# SUBDIVISION REPORT - CONCEPT/USE ON REVIEW

► **FILE #:** 9-SB-20-C

► **SUBDIVISION:** BRAKEBILL ROAD SUBDIVISION

**9-SB-20-C / 9-D-20-UR  
CONCEPT PLAN/USE ON REVIEW**

PROFILE VIEW: ROAD 'C'  
1"=50' (HORIZONTAL)  
1"=5' (VERTICAL)

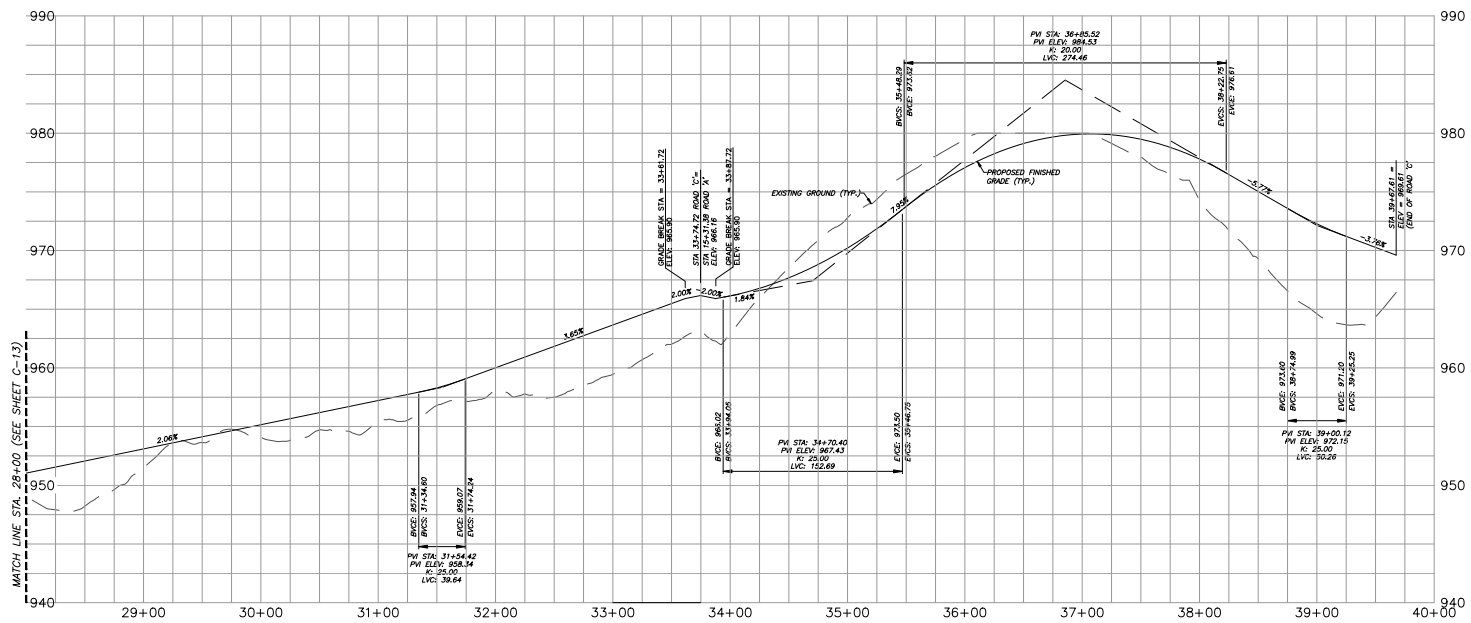
**1) REDUCE THE TANGENT BETWEEN BROKE BACK CURVES ON ROAD 'C' FROM 150 TO 118.25' BETWEEN STATIONS 13+01.59 AND 14+19.84.**

- 1) REDUCE THE CENTERLINE RADIUS ON ROAD 'C' FROM 250' TO 125' BETWEEN STATIONS 14+19.84 AND 15+40.65.
- 2) REDUCE THE CENTERLINE RADIUS ON ROAD 'C' FROM 250' TO 175' BETWEEN STATIONS 19+63.65 AND 22+95.82.

- 5) REDUCE THE CENTERLINE RADIUS ON ROAD 'E' FROM 250' TO 200' BETWEEN STATIONS 2+57.53 AND 5+59.28.
- 6) REDUCE THE MINIMUM K VALUE ON ROAD 'C' FROM 25 TO 20 BETWEEN STATIONS 1+67.56 AND 4+12.42, 17+ 10.67 AND 18+61.15, 35+27.18 AND 38+01.64.

- **APPROVE variance 1-2 and alternative design standards 1-8 based on the recommendations of the Knox County Department of Engineering and Public Works and because the site conditions restrict compliance with the Subdivision Regulations and the proposed variances and alternative design standards will not create a traffic hazard.**

PROFILE VIEW: ROAD 'D'  
1"=50' (HORIZONTAL)  
1"=5' (VERTICAL)

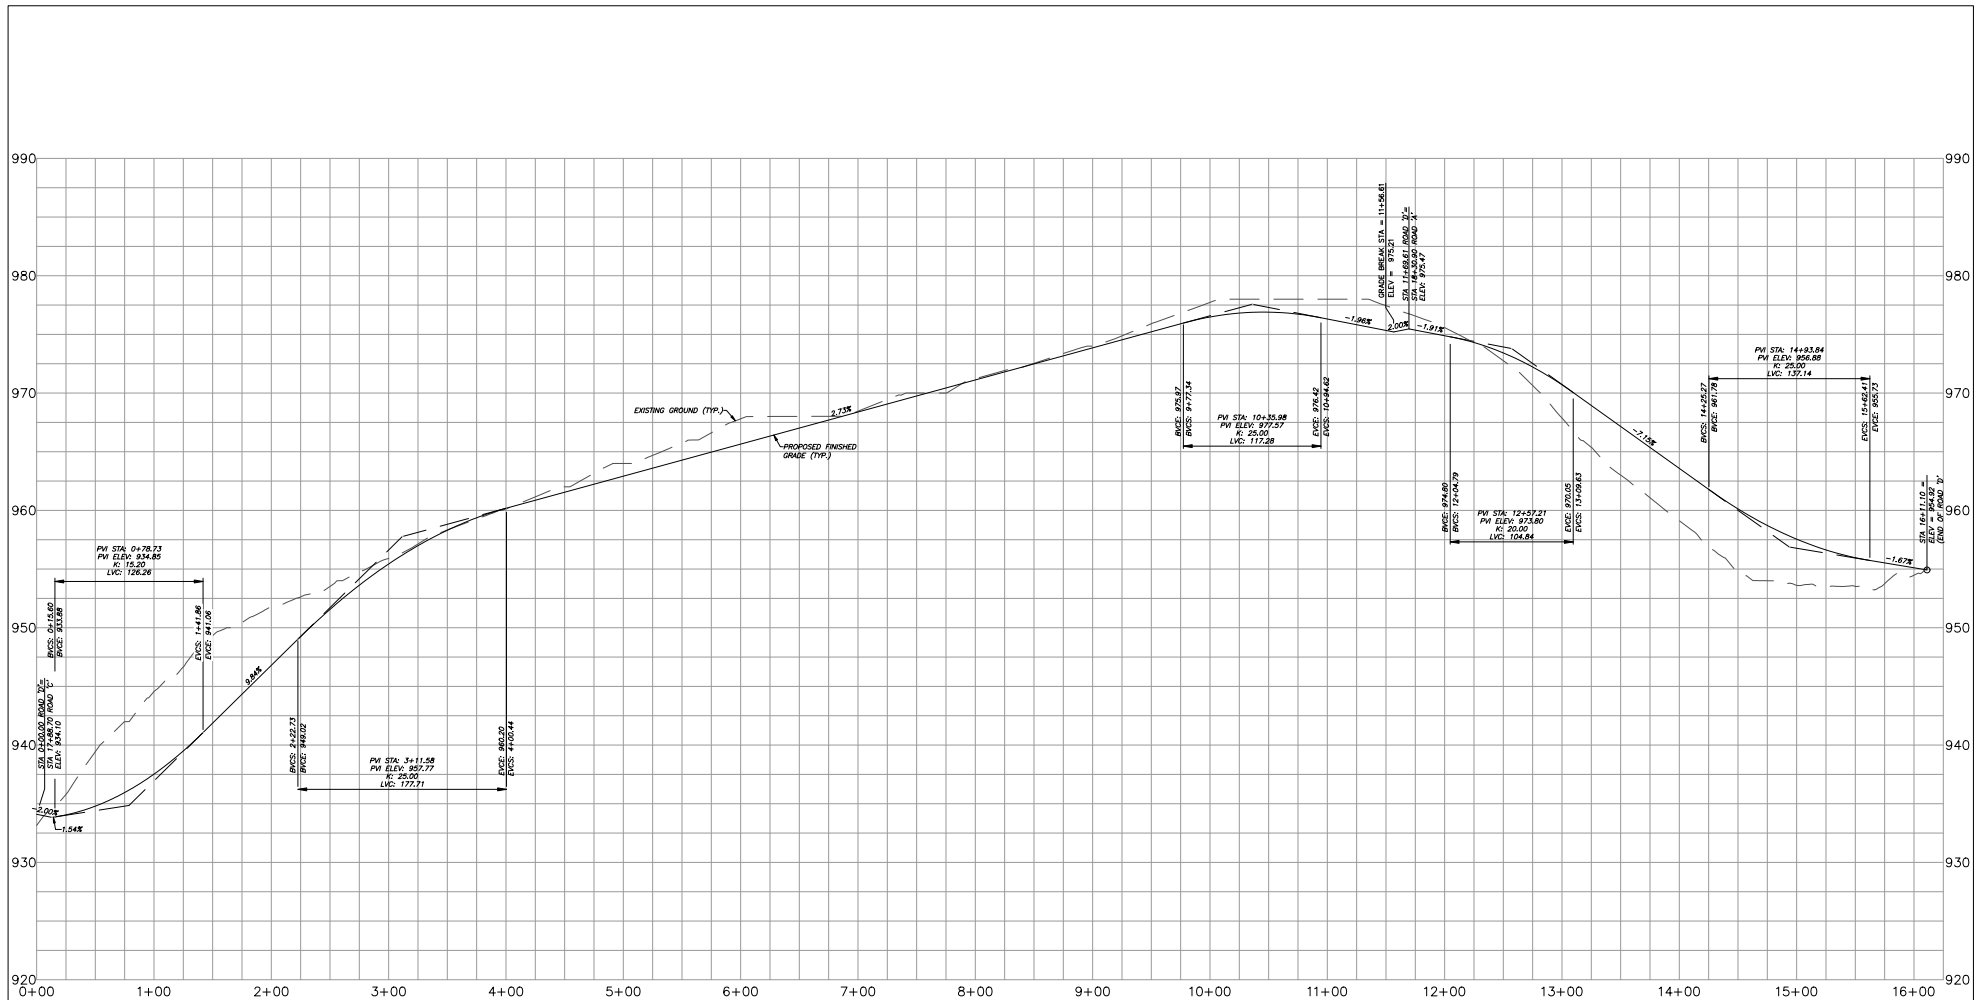
- 3) REDUCE THE CENTERLINE RADIUS ON ROAD 'D' FROM 250' TO 125' BETWEEN STATIONS 1+06.77 AND 1+44.96.
- 4) REDUCE THE CENTERLINE RADIUS ON ROAD 'E' FROM 250' TO 150' BETWEEN STATIONS 0+37.03 AND 0+98.00.

- 7) REDUCE THE MINIMUM K VALUE ON ROAD 'D' FROM 25 TO 20 BETWEEN STATIONS 12+04.79 AND 13+09.63.
- 8) REDUCE THE MINIMUM STREET FRONTAGE FOR THE ATTACHED RESIDENTIAL LOTS IN THE ROAD 'E' AND ROAD 'F' CUL-DE-SAC FROM 25' TO 16.3', AND 25' TO 20' FOR ALL OTHER ATTACHED RESIDENTIAL LOTS.

**PROFILE VIEW: ROAD 'E'**  
 1"=50' (HORIZONTAL)  
 1"=5' (VERTICAL)

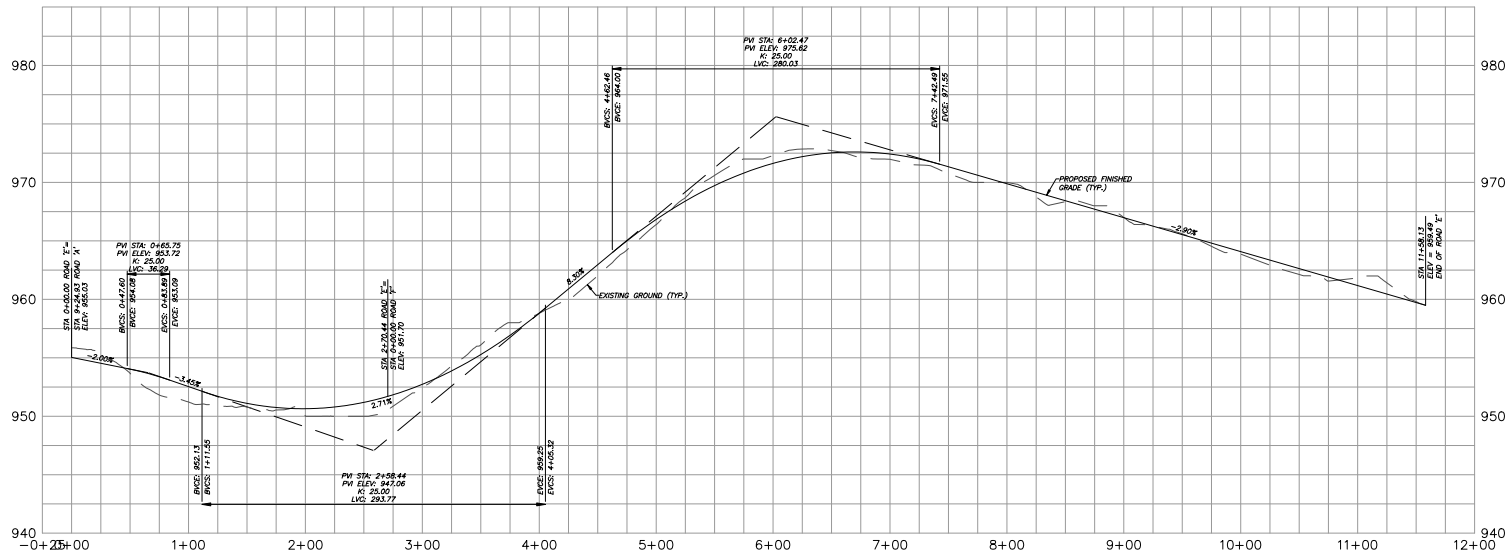
**2) REDUCE THE TANGENT BETWEEN BROKE BACK CURVES ON ROAD 'E' FROM 150 TO 23.27' BETWEEN STATIONS 2+34. 16 AND 2+57.53.**
